**Engine Fuel Filters
 VAH, VHD, VN, VT**

FSB 233-006, Engine Fuel Filters

(March 2016)

Week Number Date Code

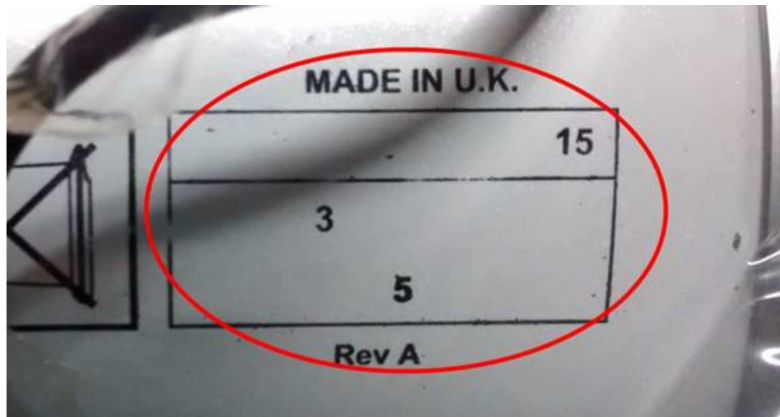
Engine fuel filters (part number 21380475) with week number date codes "15_33" (August 10, 2015) through "15_39" (September 27, 2015) should not be installed on an engine without first being inspected. The week number date code is marked on the outside of the filter, the number on top is the year and the number below identifies the week. Due to a manufacturing issue, fuel does not flow through the filter which results in a no-start/run condition immediately after installation.

W2110073

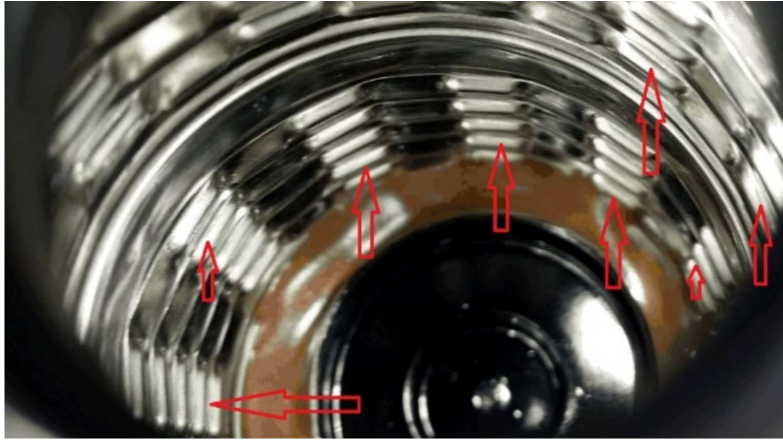
To determine if a filter can be installed on an engine, shine a flash light inside the filter to verify the holes/slits are present for fuel flow.

W2110074

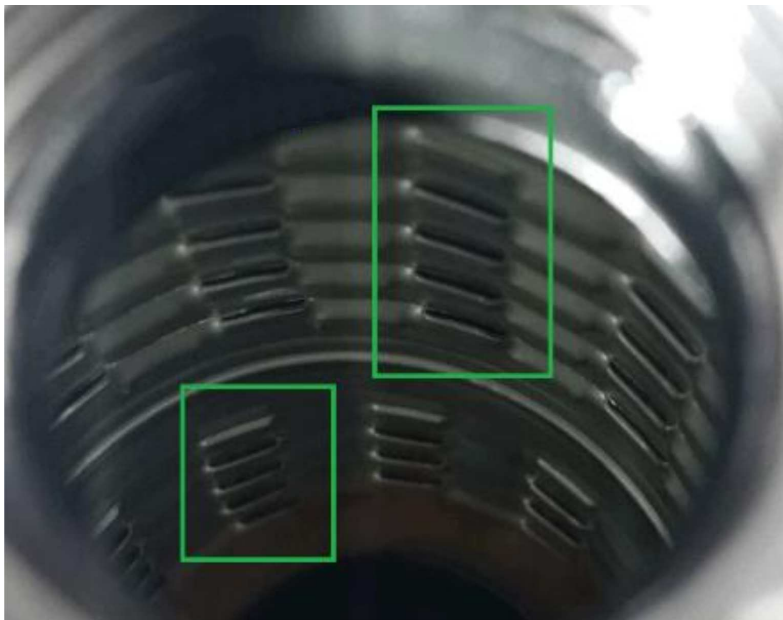
Unusable Filter

Usable Filter
